Bicycle Advisory Committee

CORRESPONDENCE

Alternate Caltrain EMU specification proposal

2) Front and rear bi-level cab cars

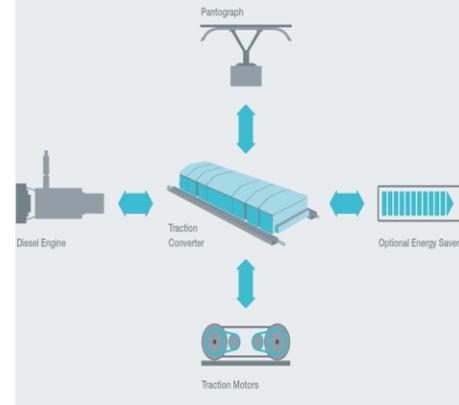
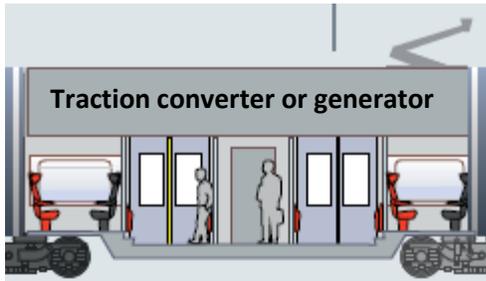
Lower deck modifications

- Remove 34 seats (for bikes)
- 8 seats (2+2) behind driver's cab
- Remove front stairs to upper deck
- Add two (total 8) flip-up seats
- Remove luggage rack
- Raise floor (eliminate step)

Upper deck modifications

- Remove front stairs to upper deck
- 2+2 seating
- Remove luggage rack
- Remove tables

- 40 bikes
- 12 seats (2+2 configuration)
- 8 flip-ups

Modified upper deck capacity

- 38 seats (2+2 configuration)
- 1 middle front bulkhead seat

3) Single level motor cars

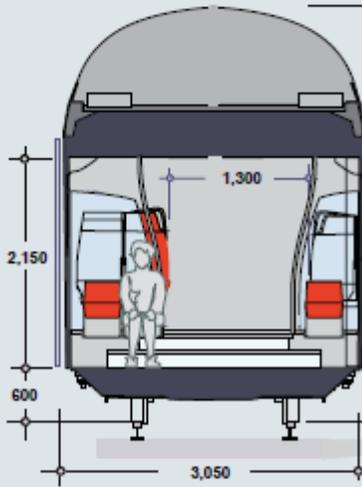
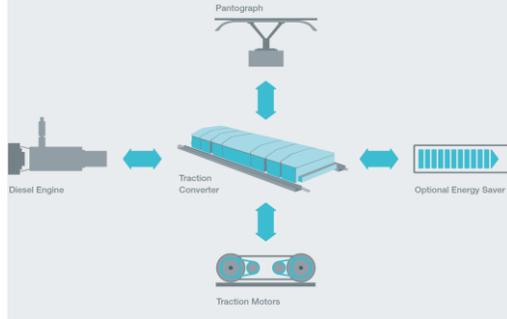
16 seats (2+2 configuration)

17 tip-ups

1 wheelchair

1 toilet
